January 7, 2013

RE: CUYAHOGA COUNTY
CITY OF BEACHWOOD
CONSTRUCTION STORM WATER
ALOFT HOTEL
PERMIT NO: 3GC06128

Fig 1. North side drainage channel looking east. Note that there is no silt fence or other perimeter control to protect the channel.

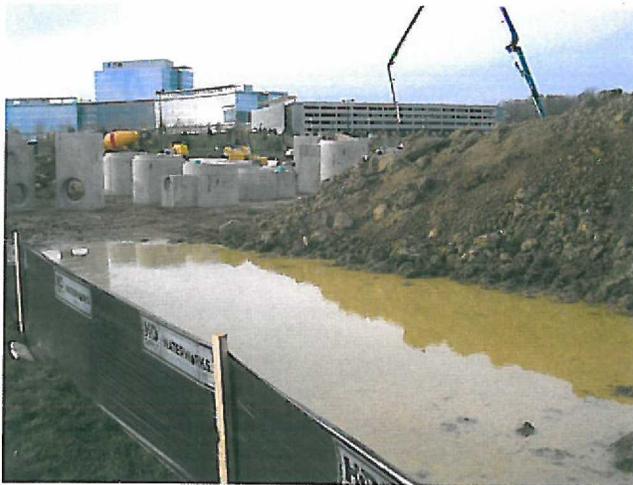
- **Perimeter controls were not installed to protect the drainage channel along the north side of the site from sediment-laden runoff.** Mr. Booth was instructed to install a silt fence, filter sock or compost berm along the north edge of disturbance to establish perimeter sediment control. NOTE: It is understood that the drainage channel will be enclosed in a pipe. These perimeter controls may have to be relocated or may not be required once the channel is enclosed. After the channel is enclosed, please assess site grades and if disturbed areas are still sloped toward the north, provide one of the aforementioned perimeter controls. Ensure storm drain inlet protection is installed on all storm sewer catch basins.
